LAKE PONTCHARTRAIN, LA. AND VICINITY
CHALMETTE AREA PLAN

DESIGN MEMORANDUM No. 5
DETAIL DESIGN
BAYOU BIENVENUE AND BAYOU DUPRE
CONTROL STRUCTURES

LMVED-TD (NOD 25 Jun 68) 7th Ind
SUBJECT: Lake Pontchartrain, Louisiana and Vicinity, Chalmette Area Plan,
Detail Design Memorandum No. 5, Bayous Bienvenue and Dupre
Control Structures

COMMENTS ON DESIGN MEMORANDUM NO. 5, DETAIL DESIGN, BAYOU BIENVENUE AND BAYOU DUPRE CONTROL STRUCTURES, LAKE PONTCHARTRAIN, LOUISIANA AND VICINITY, CHALMETTE AREA PLAN, INCLOSED WITH LETTER, LMNED-PP, 25 JUNE 1968, SUBJECT: LAKE PONTCHARTRAIN, LOUISIANA AND VICINITY, CHALMETTE AREA PLAN, DETAIL DESIGN MEMORANDUM NO. 5, BAYOUS BIENVENUE AND DUPRE CONTROL STRUCTURES

LAKE PONTCHARTRAIN, LA. AND VICINITY
CHALMETTE AREA PLAN
DESIGN MEMORANDUM NO. 5—DETAIL DESIGN
BAYOUS BIENVENUE AND DUPRE CONTROL STRUCTURES
BASE SLAB
HALF PLAN AND ELEVATION
SCALES AS SHOWN

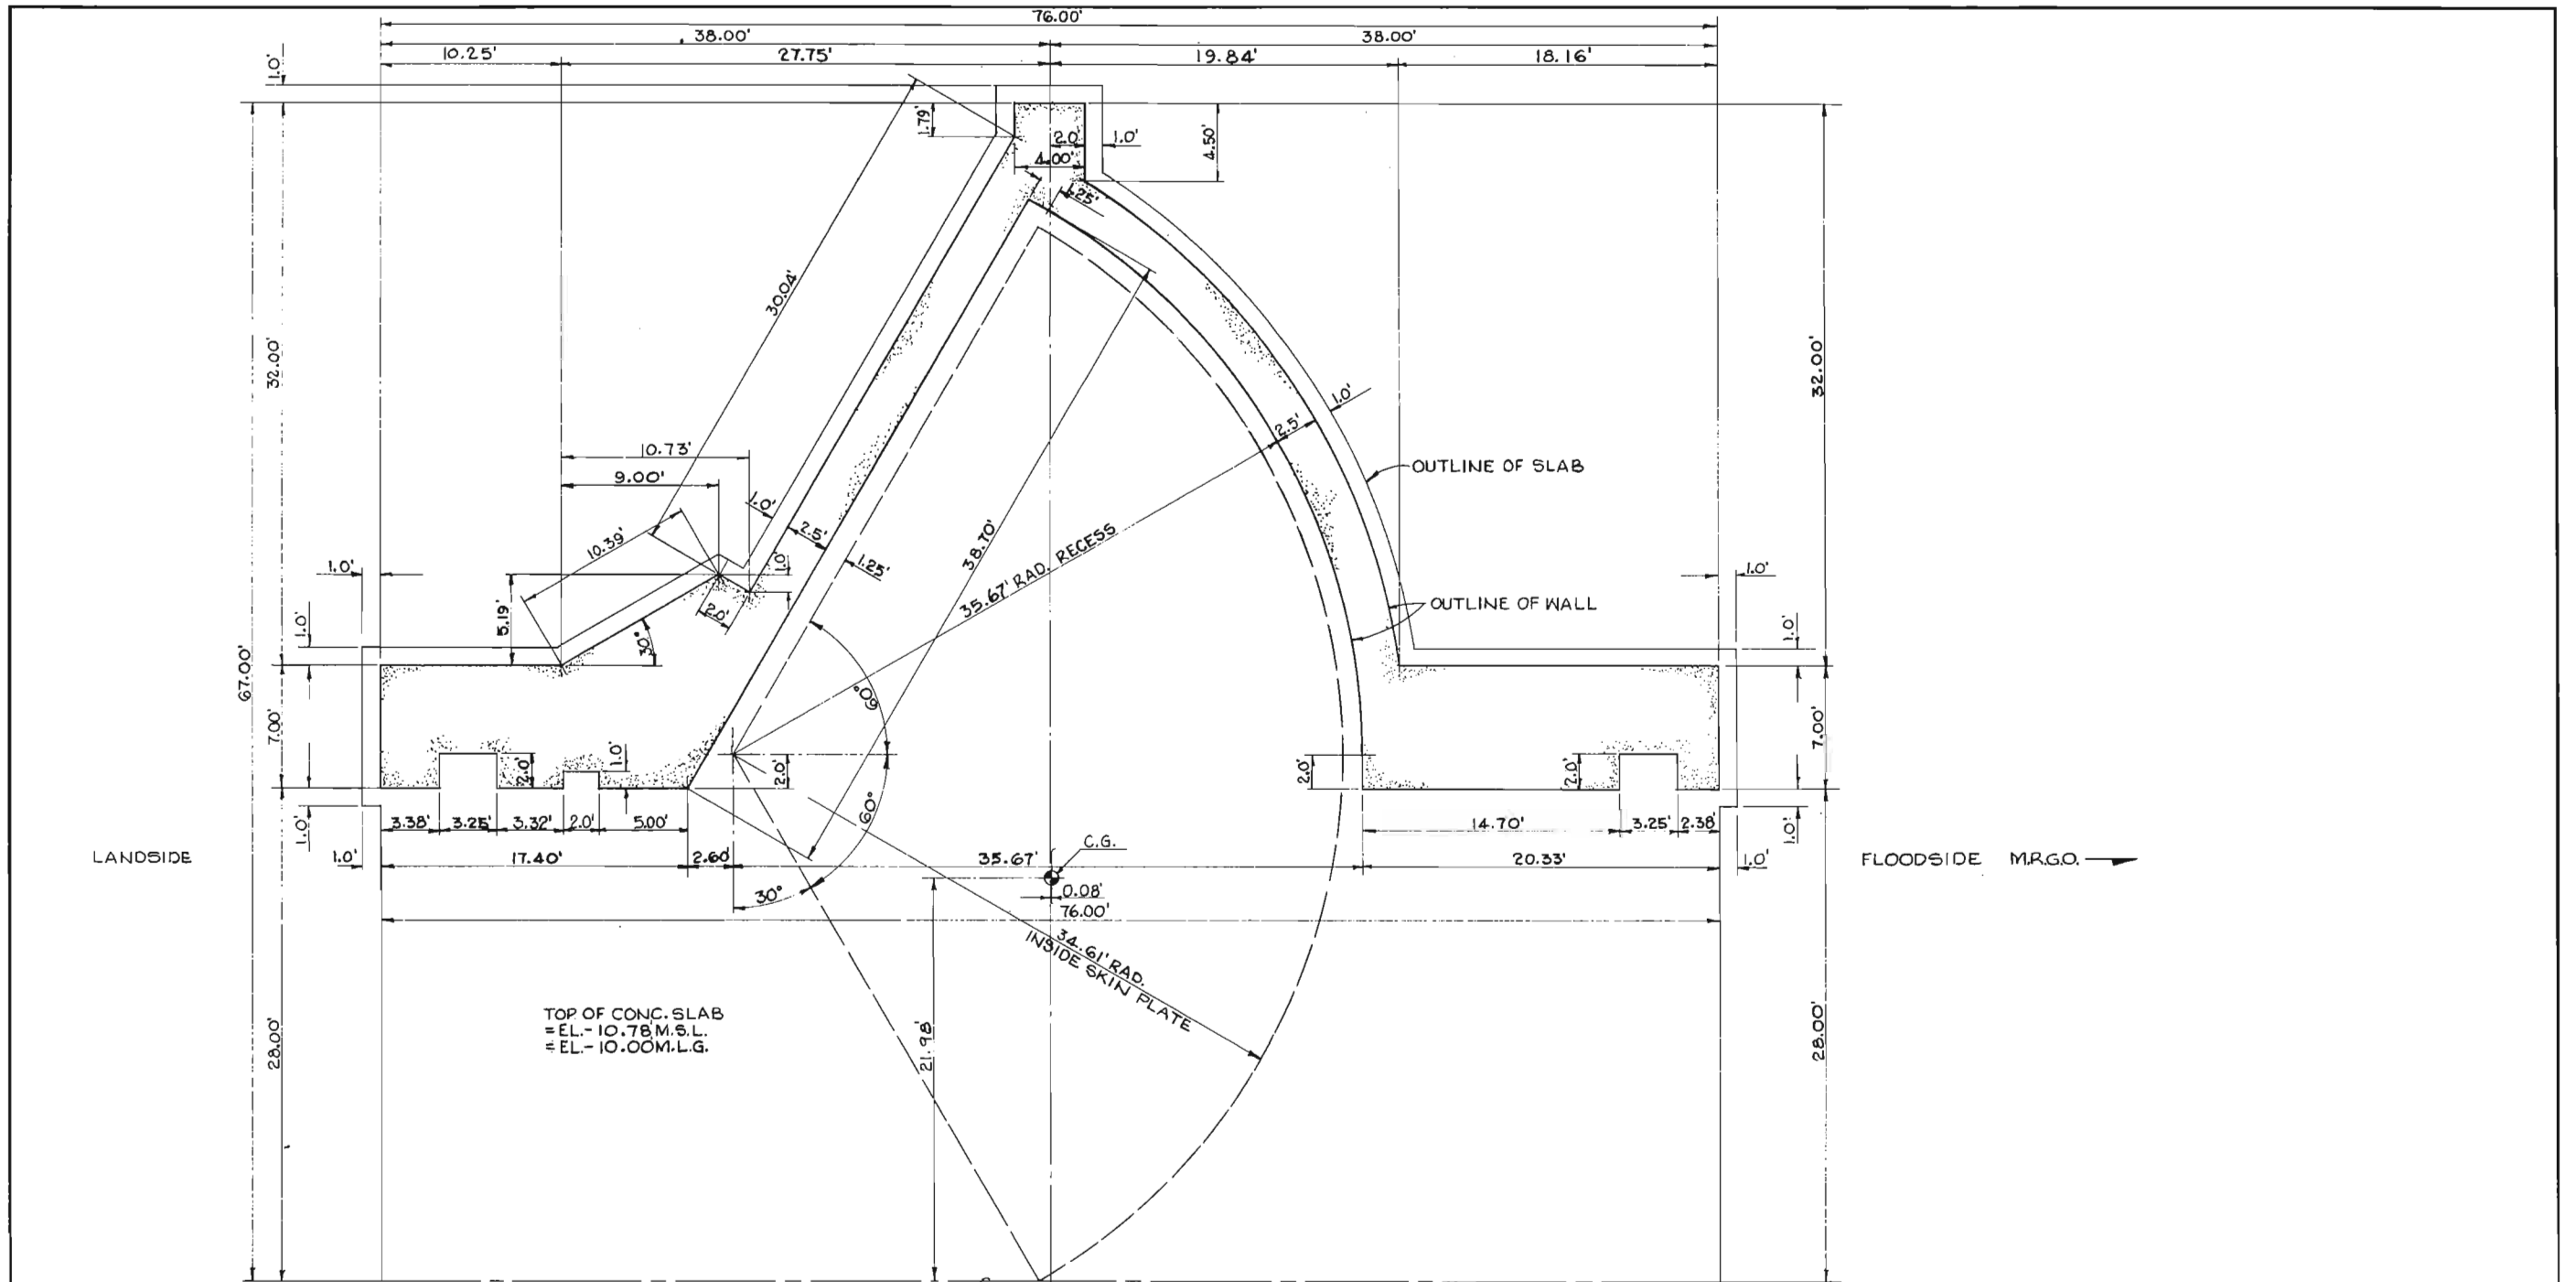
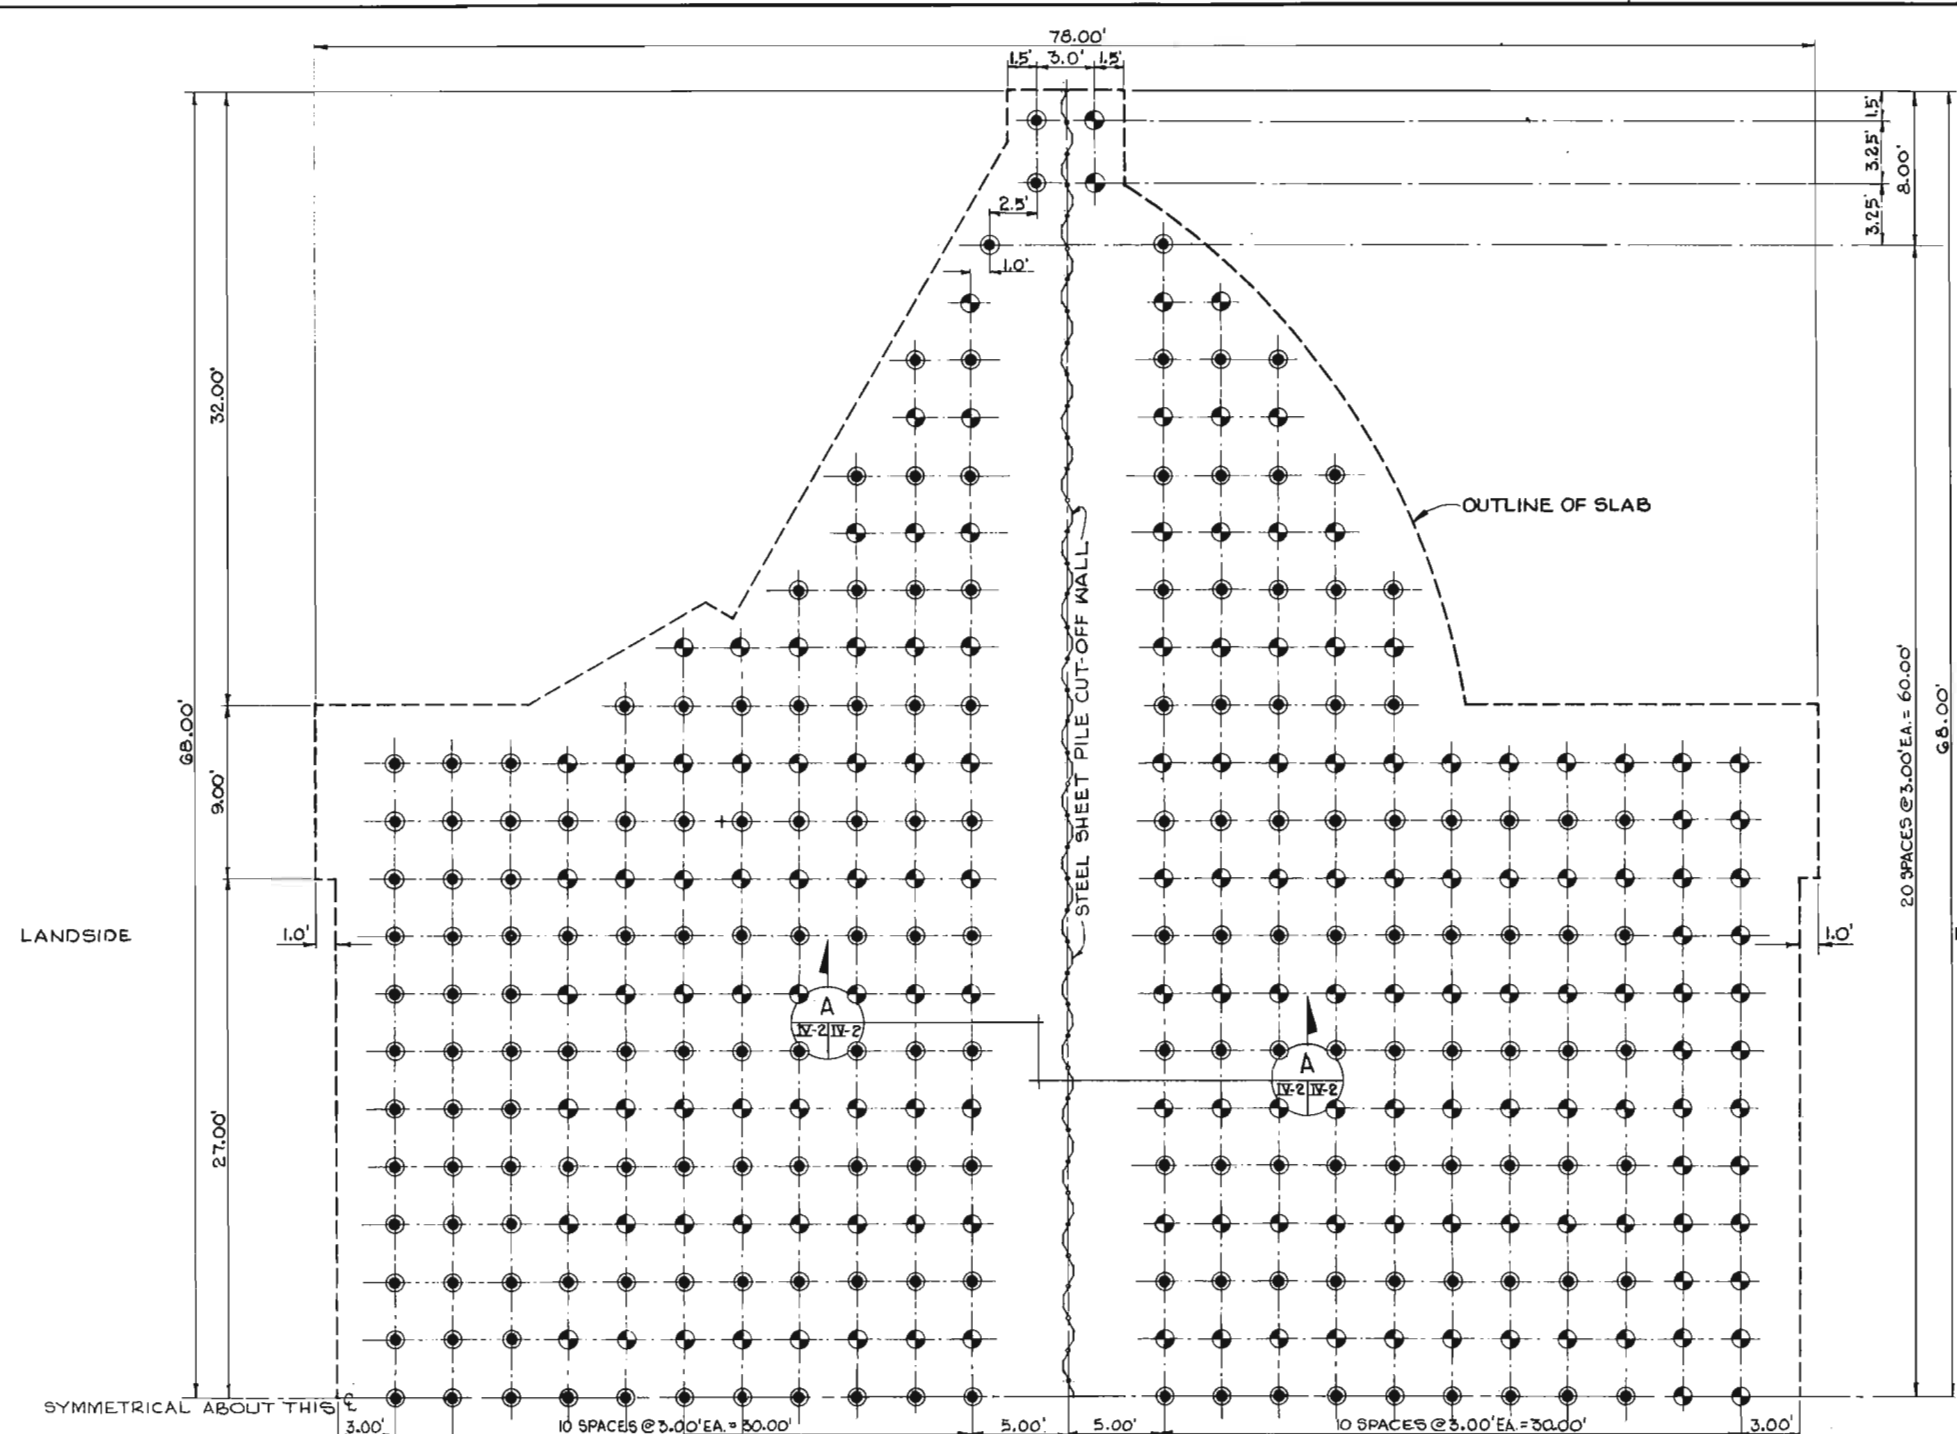
1. Design Memorandum No. 5 is approved, subject to the comments of the Division Engineer and the following comments.
2. Plate IV-2, Section A. Consideration should be given to extending the steel sheet piling (MA-22) to elevation -36.00. This would get the sheet piling through the sand layer, thus giving more positive protection against piping. The 5.00' impervious clay layer on each side of the steel sheet piling (MA-22) should be eliminated and replaced with a 12" layer of clam shells.

3. Plate IV-2, Piling Layout Half Plan. To allow the steel sheet piling to be driven to elevation -36.00, the battered pile should be shifted one foot to landside and one foot to the floodside, changing the two 5.00' dimensions in the middle to 6.00' and the 3.00' dimensions at each edge to 2.00'.

2. Para 2. a. As previously discussed in the 1st Ind to NOD letter dated 2 Nov 67, subject: "Lake Pontchartrain, Louisiana and Vicinity, Chalmette Area Plan, Detail Design Memorandum No. 5 - Bayous Bienvenue and Dupre Control Structures (2d Draft)," if the primary purpose of the steel sheet pile cutoff wall beneath the gate bay structure and the inverted "tee" floodwall is to control piping directly beneath the base slab should roofing occur, we consider that the proposed cutoff tip elevation of -26.0 is satisfactory.

b. OCE's comment is directed to consideration of the steel sheet pile cutoff for controlling seepage and piping in the lower sand stratum. In investigating such a cutoff in these sands, it is noted that a cutoff tip elevation of -36.0 would be satisfactory for the Bayou Bienvenue structure as indicated by borings on Plates III-1 and III-4 of the DM. However, a cutoff tip elevation of -36.0 is not adequate for the Bayou Dupre structure as evidenced by borings shown on Plates III-3 and III-4. The steel sheet pile cutoff for this structure should penetrate to approximate el -50.

3. Para 3. The suggested revision to the piling layout will raise the elastic center of the pile foundation, thus increasing the moment about the elastic center and resulting in greater pile loads. Present maximum pile loads are near the design load of 32 kips for group 1 loads and 43 kips for group 2 loads. See cases 4 and 4-A on Plate IV-6 for maximum group 1 loads, and cases 6 and 6-A on Plate IV-8 for maximum group 2 loads. The change will require reanalysis and possibly greater pile penetration. Note that certain piles adjacent to the floodside of the gate recesses cannot be shifted due to minimum clearance from the edge of the concrete slab. At these locations, the pile spacing must be reduced. Comments in para 2b above must be considered in evaluation of the Bayou Dupre pile spacing should the steel sheet piling (MA-22) be extended to cut off the lower sands.
